ADDENDUM NUMBER TWO - RFP 13-2277 CLUBHOUSE RESTROOM REMODEL - GLENDOVEER GOLF COURSE AND TENNIS CENTER

Attachment A-Addendum Two
RFB 13-2277

SUBJECT: Substitution Request- Glendoveer Golf Course Clubhouse Restroom Remodel

Model
SS-3001
 Oval Undermount Lavatory

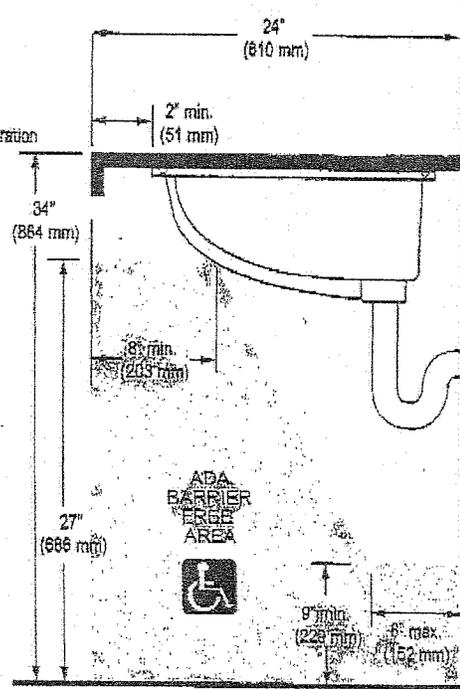
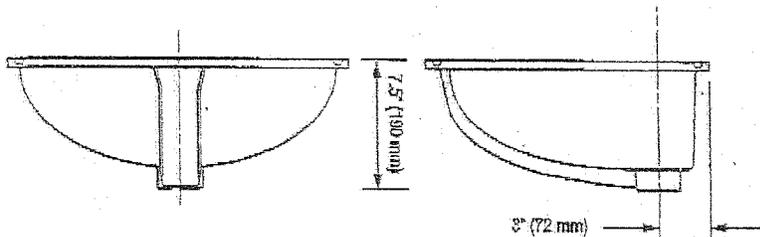
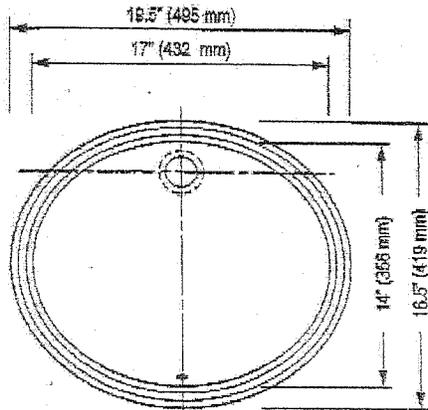
Section	Page	Paragraph	Description
<u>P.O.</u>		<u>Fixture Schedule</u>	<u>L-1 Lavatory Vitaeous China</u>

PROPOSED SUBSTITUTION: Sloan Fixtures SS-3001

- Q1: Are stubouts for power and plumbing for the walk in cooler and ice machine included in the base bid located in the storage room?
A1: Yes.
- Q2: A substitution request was received to make all fixtures consistent by specifying Sloan.
A2: The request is approved and is attached as Attachment A to this addendum.

Model
SU-1005-0.5
Vitrous China Urinal

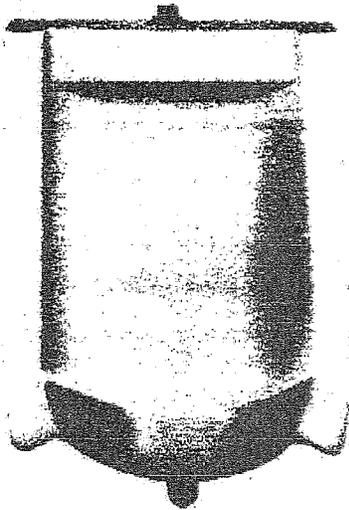
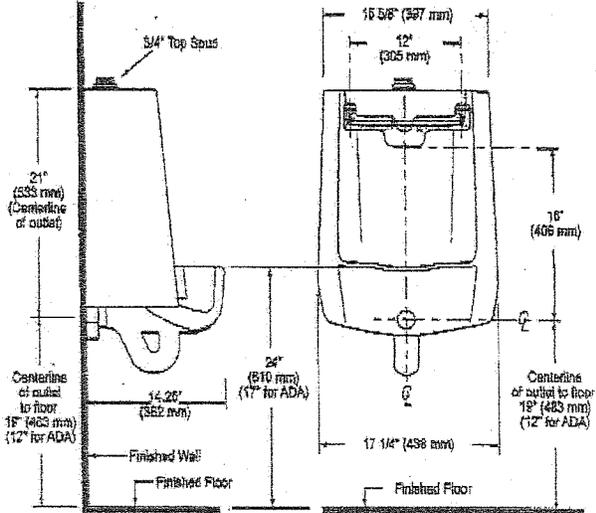
<u>Po.0</u>	<u>Fixture Schedule</u>	<u>U-1+2</u>	<u>Unaided Vitreous China</u>
Section	Page	Paragraph	Description

PROPOSED SUBSTITUTION: Sloan Fixtures SU-1005-0.5

Model
ST-2053-1.6
Vitreous China Water Closet

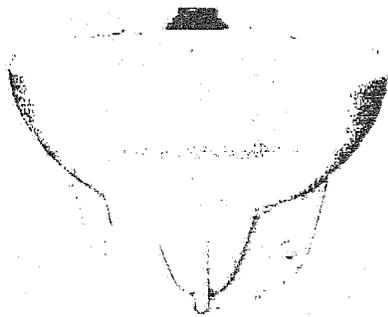
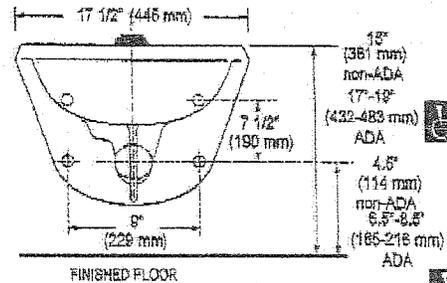
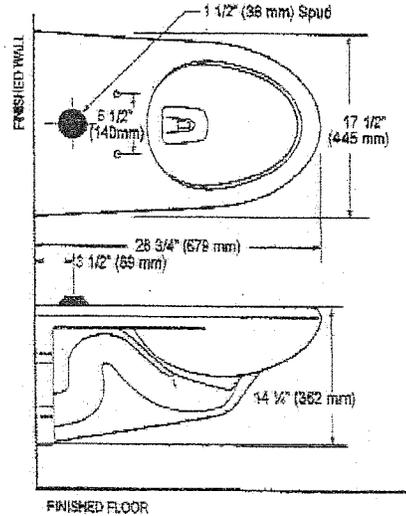
Section	Page	Paragraph	Description
<u>PO.0</u>	<u>Fixture Schedule</u>	<u>WC-1+2</u>	<u>Water Closet Vitreous China</u>

PROPOSED SUBSTITUTION: Sloan Fixtures ST-2053-1.6
